802.3cu D1p0 TDECQ-SECQ considerations.

Background

A new transmitter parameter, TDECQ-SECQ has been introduced into D1p0 Table 151–7 applicable to 400GBASE-LR4 PMD only.

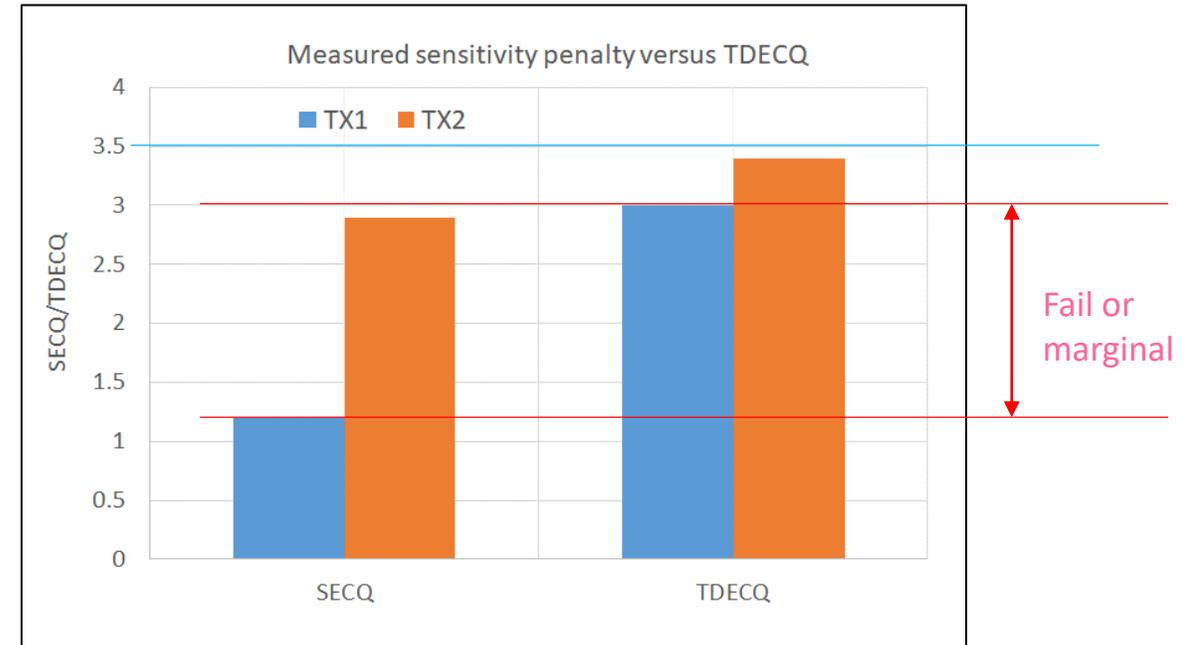
Because they rely on the difference of two parameters taken under different propagation conditions.

Considering the TDECQ reference transmitter, TDECQ-SECQ penalty would more easily diverge from the real receiver under propagation conditions.

- SECQ (TDECQ at $km=0$) would have a better fit with real receivers, and less results variation because the 1% threshold optimization will keep it almost stable.
- While TDECQ at maximum dispersion would probably need more than 1% threshold adjustment, the result is expected to be less stable considering the current.

Thus TDECQ-SECQ can not be an accurate metric.

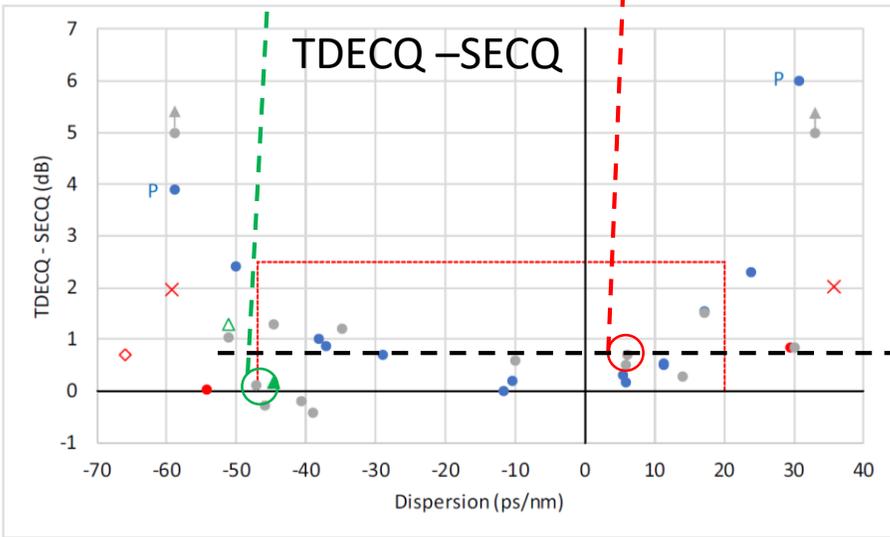
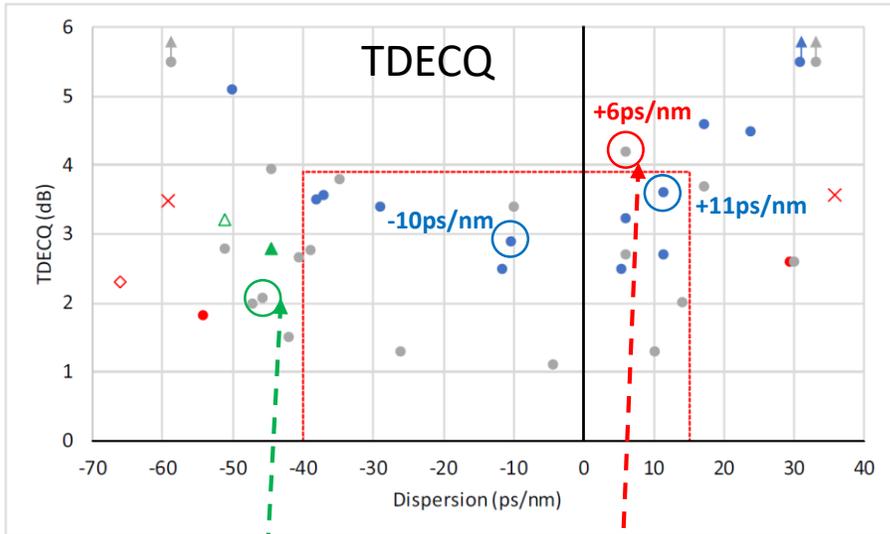
TDECQ-SECQ can actually potentially penalize 'virtuous' transmitters with low SECQ, which can still meet the absolute TDECQ at the worst case fiber propagation conditions, but fail this just this new parameter.

If TDECQ-SECQ will not be carefully quantified, what can then happen then is the absurde situation that after propagation tests a 'good' transmitter ends with lower TDECQ with respect a worse one, but just fails the new TDECQ-SECQ metric ...

This because the added Noise/Distorsion 'equivalent' sigma generated by chromatic dispersion will affect more transmitters having the merit to have a lower Noise/Distortion sigma (corresponding to lower SECQ), while having less impact on trasmitters starting with higher SECQ.

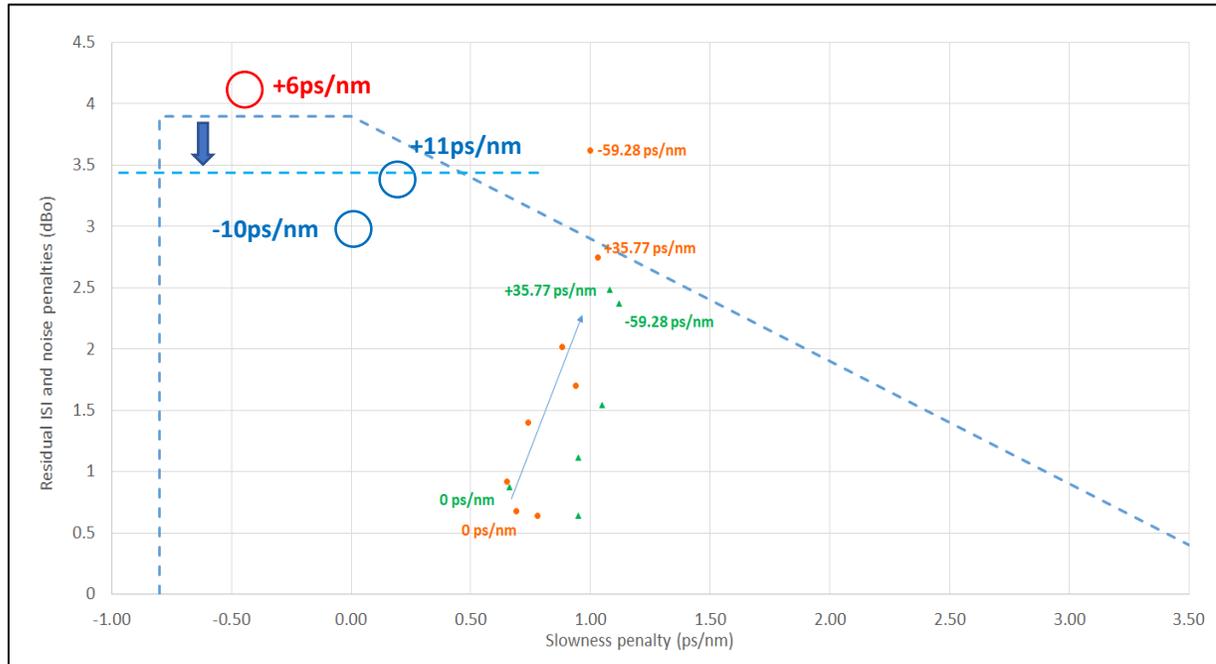
Into [stassar 3cu 01 0919](#) a TDECQ chart with scattered results was reported (slide 6), observing that the TDECQ-SECQ chart (slide 7) can be scattered was more consistent to quantify the CD penalty.

However, scattered TDECQ values can be considered normal if the transmitters were pre-distorted to deal with CD.

Based on same charts, the example is showing that two point at low TDECQ-SECQ have quite different TDECQ, which make clear that TDECQ-SECQ is not going to catch pre-distorted transmitter which distortion cannot be equalized.

While TDECQ-10Log(Ceq) will catch this difference, having being defined for it.

- High TDECQ and low TDECQ-SECQ (so high SECQ) -> Distortion penalty -> high TDECQ-10Log(Ceq)
- Low TDECQ and low TDECQ-SECQ -> Distortion penalty -> Low TDECQ-10Log(Ceq)
- [yu_optx 01a 0319](#) measurements

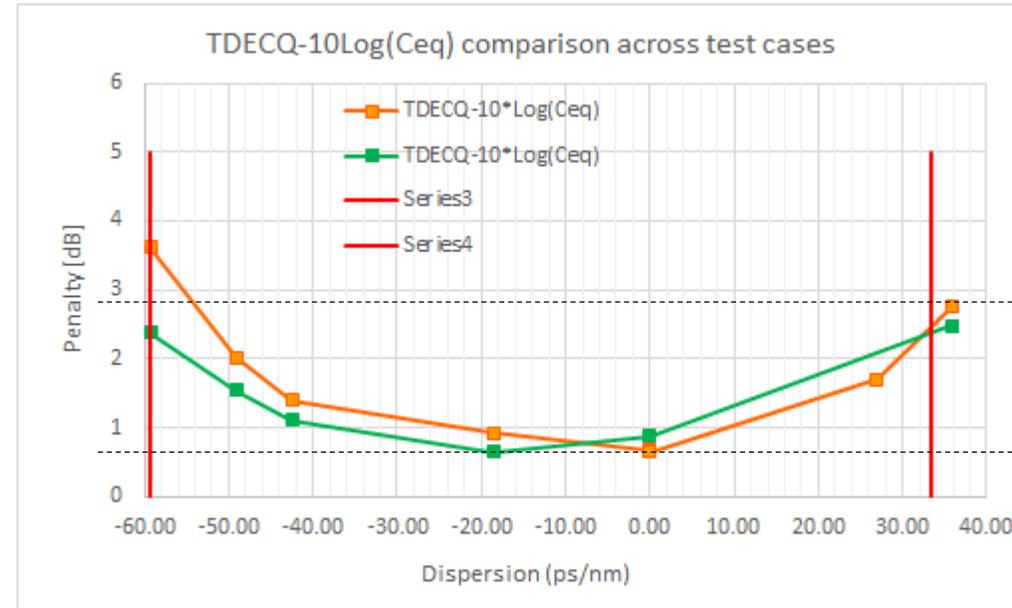
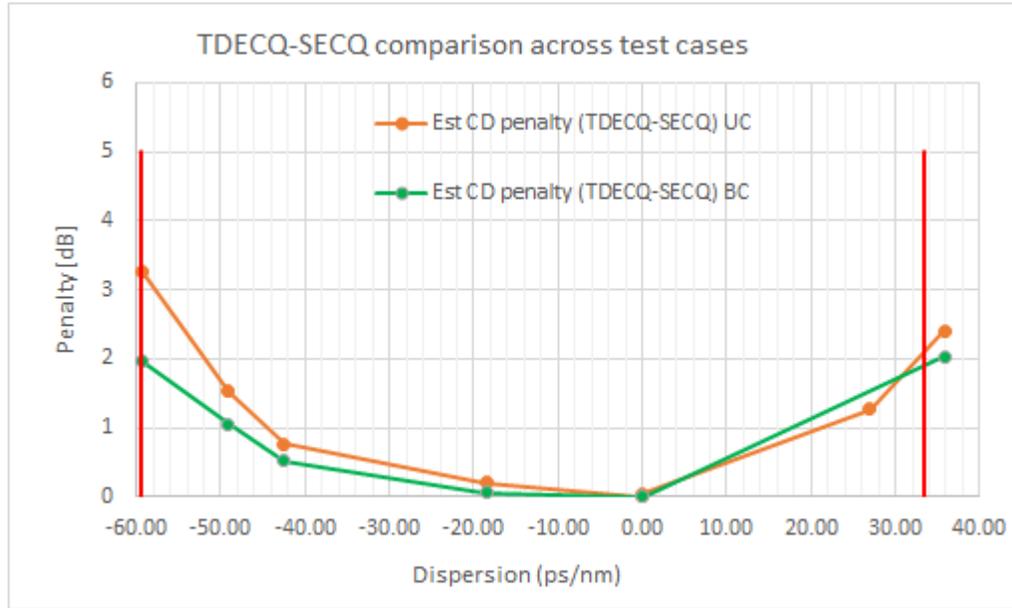
Plot of dispersion penalty results from [mazzini_3cu_adhoc_082119](#) for uniform level spacing and bottom compression. Orange and green showing CD penalty trend being partially equalized and improvement due to bottom compression.

Red and Blue circles are estimations of worst cases 100G Lambda MSA and [yu_optx_01a_0319](#) TDECQ and TDECQ-SECQ measurements from previous slides.

Because referring to very small dispersion, both cases seems heavily pre-distorted.

To avoid these cases, one option would to furtherly tight the TDECQ-10Log(Ceq) limit, by not aligning it anymore with TDECQ.

Potential TDECQ-SECQ conformance test block diagram

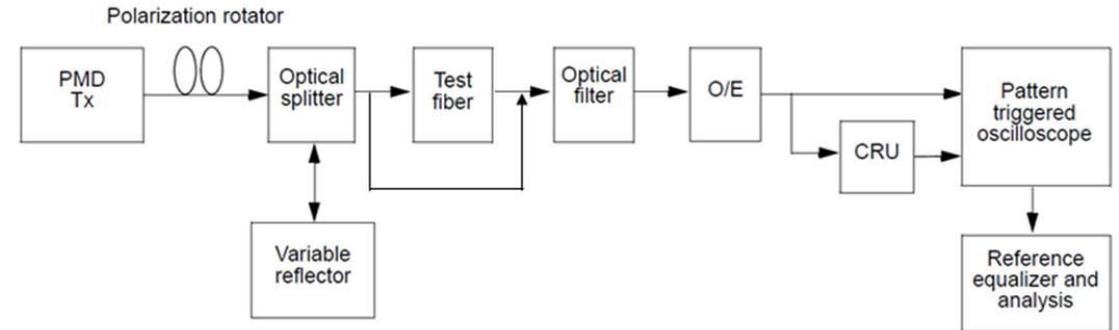
In manufacturing it will require a controlled environment in which, not only the TDECQ at the worst chromatic dispersion will have to be tested (and one can choose it own corner case test, once defined it in case), but ALSO the transmitter SECQ, run two tests: one for SECQ with 0 ps/nm dispersion and then one for TDECQ with worst case dispersion – doubling the testing time and then costs.

For multi-wavelength PMD (like 400GBASE-LR4) this will have of course more impact.
